ADDENDUM # 001

February 23, 2006

Missouri Department of Transportation – “Central Office – HVAC Renovation”

REVISED PIPING RENOVATION PLAN

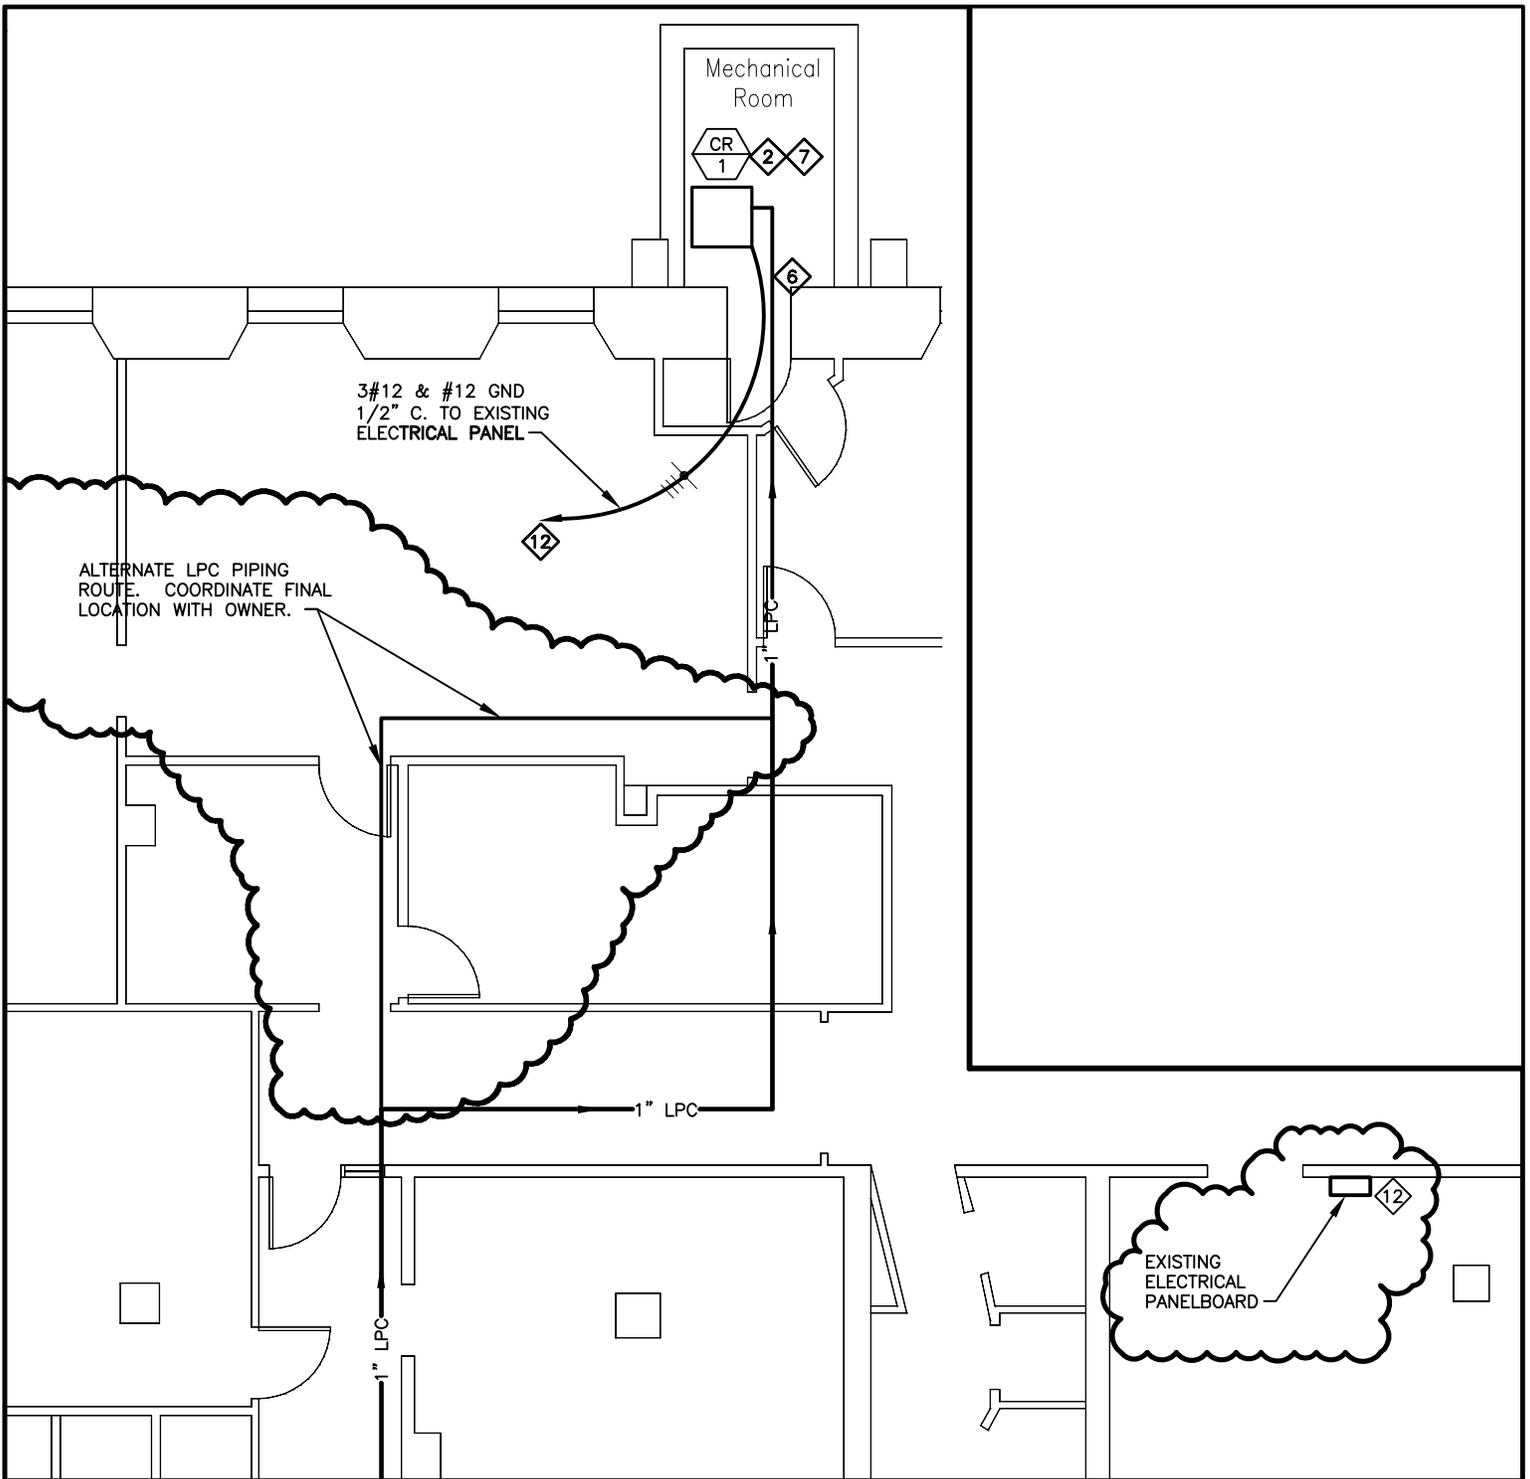
ITEM No. 1: Alternate general route for low pressure condensate (LPC) is show on R1-M1.3 Revised Piping Renovation Plan. Coordinate LPC routing with owner’s representative prior to pipe installation.

ITEM No. 2: Location of electrical panel for electrical service to new condensate return pump shall be as shown on R1-M1.3 Revised Piping Renovation Plan. Existing 15 amp circuit to be demo’d does not originate from this panel.
